Re: New Construction
9101 Central Ave. NW
Traffic Circulation Layout
Architect's Stamp 12-09-21 (K9-D001)

Based upon the information provided in your submittal received 07-25-22, the above referenced plan cannot be approved for Building Permit until the following comments are addressed:

Site Plan & Details

SP-102

1 SITE DIMENSIONS PLAN

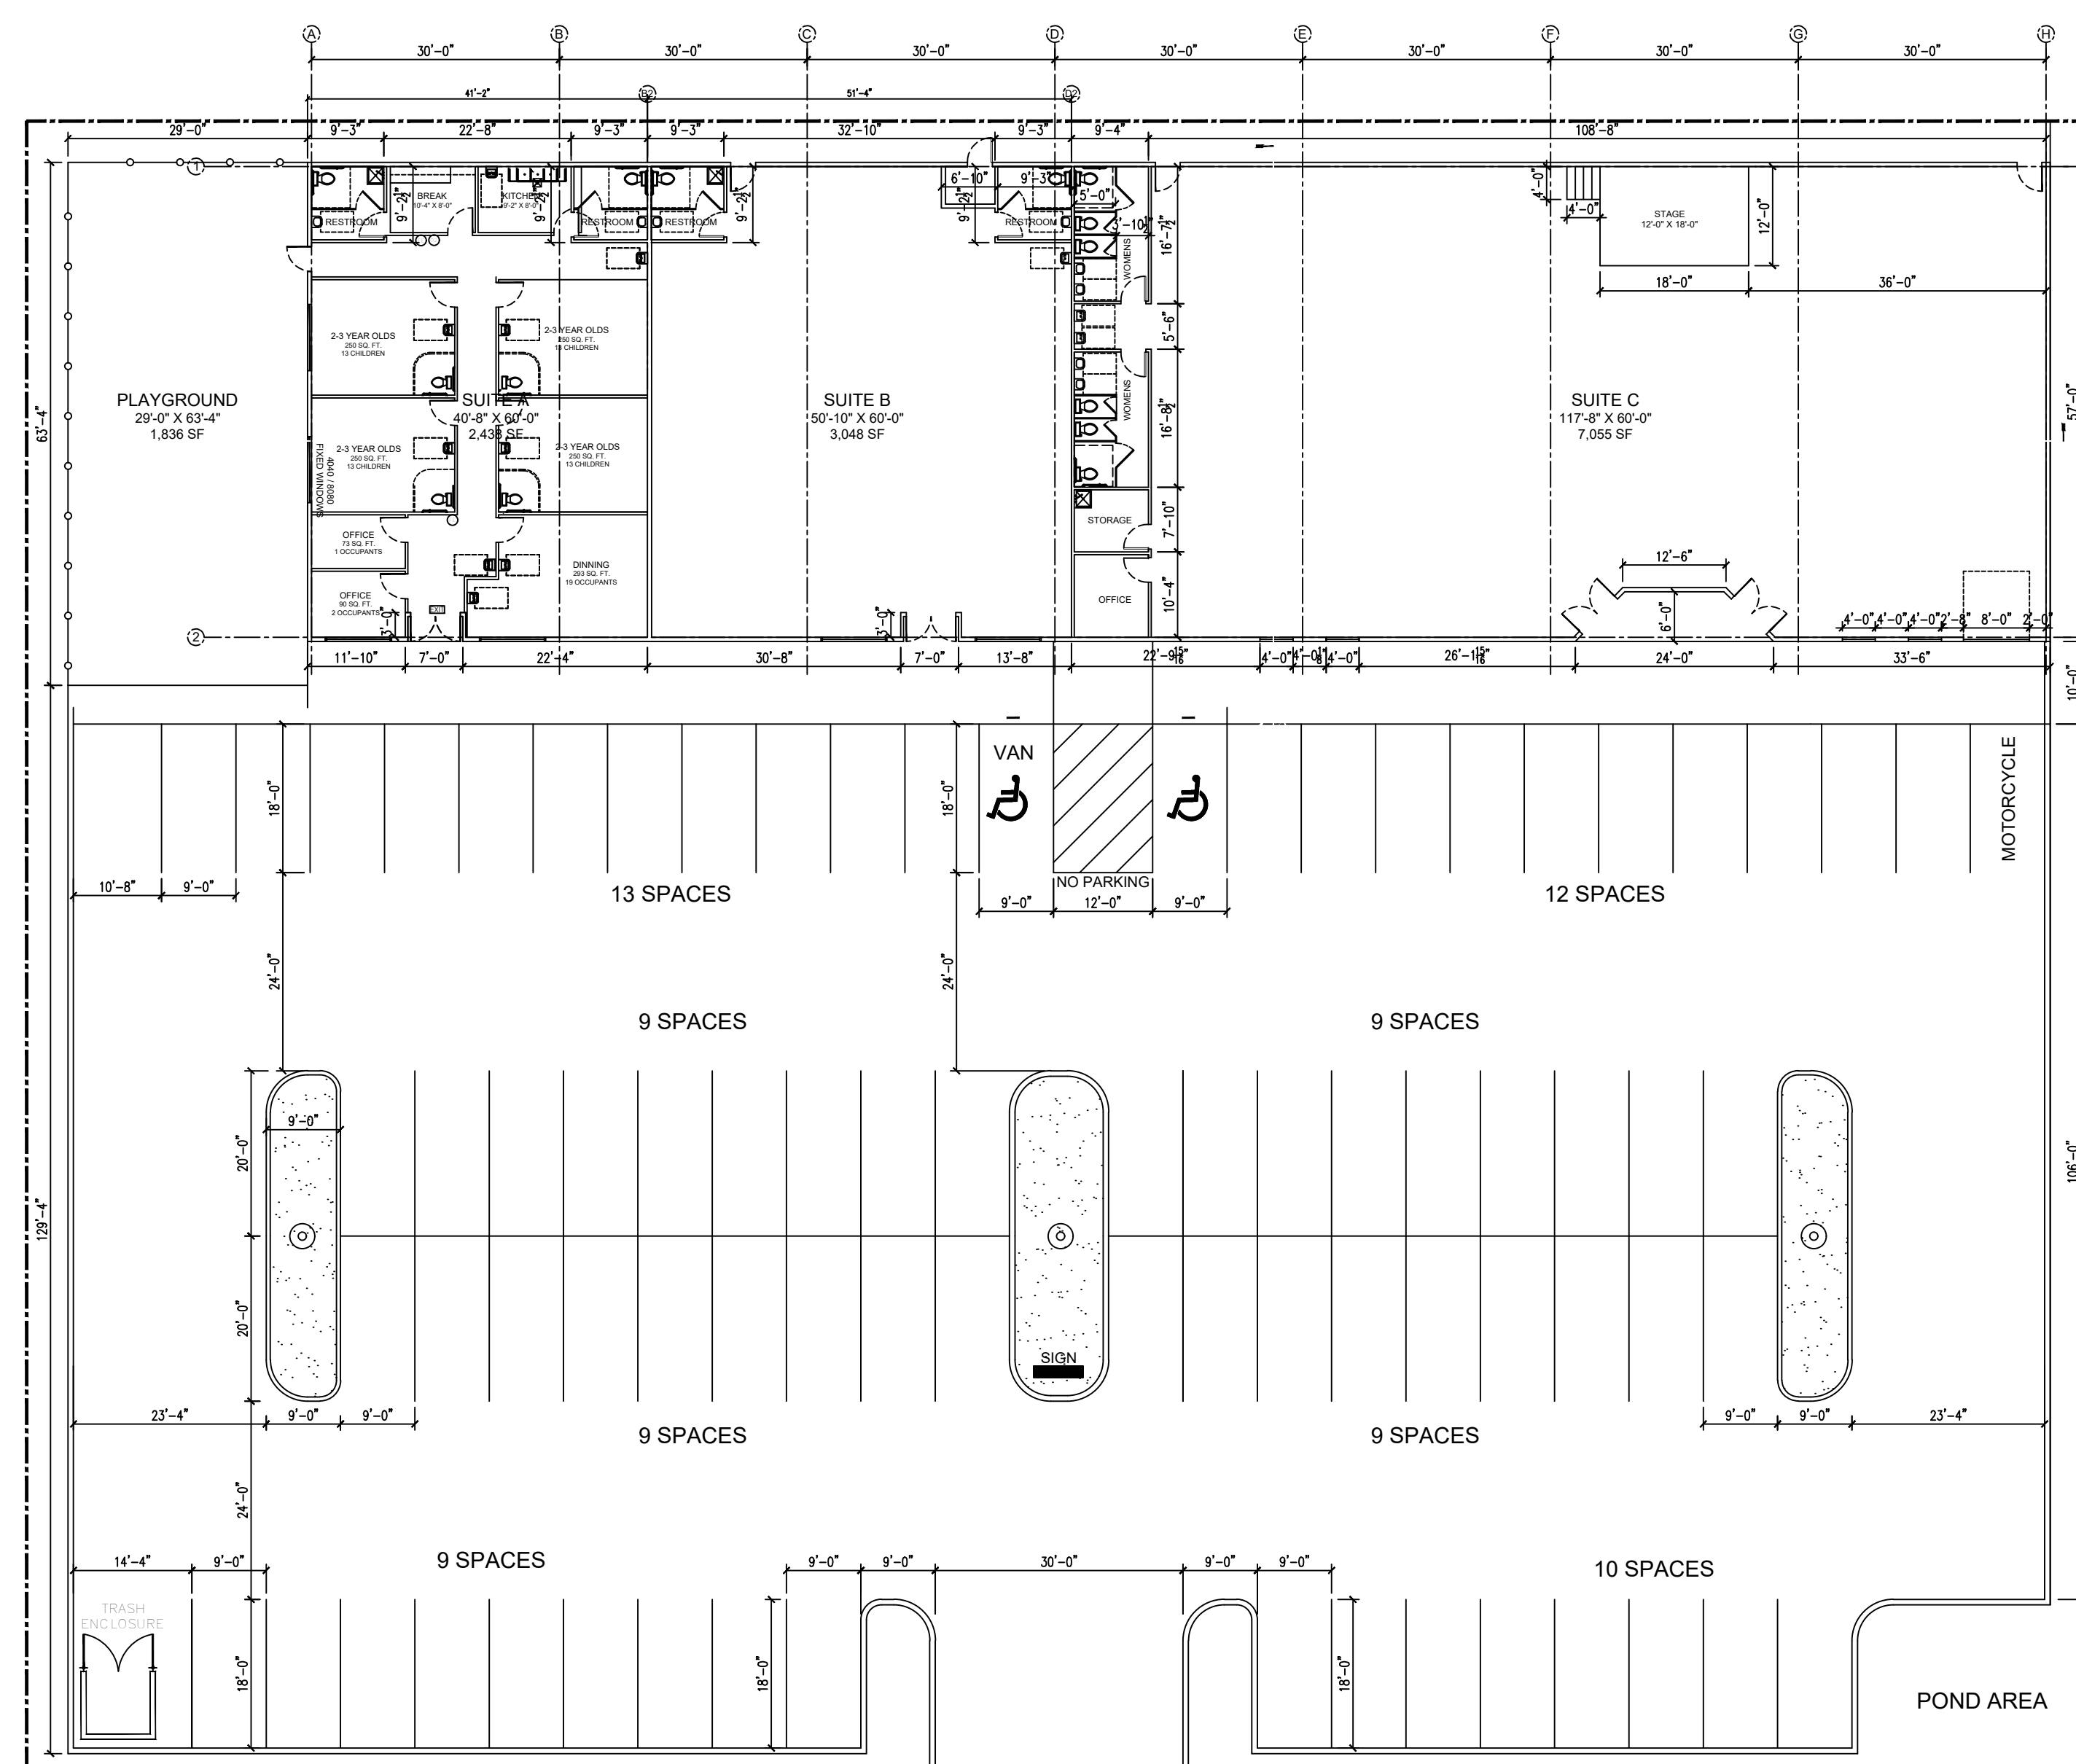
1. Please show a vicinity map showing the location of the development in relation to streets and well known landmarks.
2. List the number of parking spaces required by the IDO as well as the proposed number of parking spaces including bicycle and motorcycle parking.
3. Identify the right of way width, medians, curb cuts, and street widths on Central Ave NW.
4. Curb Return design is recommended for the driveway access off Central Ave.
5. Sidewalk and curb and gutter need to be build off Central Ave. from property line to property line. Reference COA std dwg 2430 & 2415A. For Sidewalk waiver please contact Ernest Armijo earmijo@cabq.gov at (505)-924-3991
6. What is the name of the proposed building?
7. Please list the width and length for all existing and proposed parking spaces. Some dimensions are not shown.
8. The minimum parking stall dimensions are:

9. The ADA accessible parking sign must have the required language per 66-7-352.4C NMSA 1978 **"Violators Are Subject to a Fine and/or Towing."** Please call out detail and location of signs.
10. A 5 ft. keyway is required for dead-end parking aisles.

16. List radii for all curves shown; for passenger vehicles. Radius for delivery trucks, fire trucks, etc. is 25 ft. or larger.
17. Per the IDO, a 6 ft. wide ADA accessible pedestrian pathway is required from the public sidewalk to the building entrances. Please clearly show this pathway and provide details.

18. Per DPM, a 6 ft. wide ADA accessible pedestrian pathway is required from the ADA parking stall access aisles to the building entrances. Please clearly show this pathway and provide details.

19. ADA accessible pedestrian pathway should not be placed behind parking space or adjacent to a vehicular way. Vehicle and pedestrian/wheel chair conflicts should be avoided as much as possible.

20. Please define the pathway, provide dimensions, show if there are any ramps, and provide ramps details.
21. Curbing should be installed to delineate landscape, parking, and pedestrian ways and identify points of access. Please call out detail and location of barrier curb.

22. Parking areas shall have barriers to prevent vehicles from extending over public sidewalk, public right-of-way, or abutting lots.
23. Refuse vehicle maneuvering shall be contained on-site. The refuse vehicle shall not back into the public right of way.; provide a copy of refuse approval.

24. Provide a copy of Fire Marshal Approval.
25. It is not apparent what type of pavement surface is being proposed. A hard driving surface will be required as part of this proposed project for parking area and drive aisles.

27. Show the clear sight triangle and add the following note to the plan: "Landscaping and signage will not interfere with clear sight requirements. Therefore, signs, walls, trees, and shrubbery between 3 and 8 feet tall (as measured from the gutter pan) will not be acceptable in the clear sight triangle.
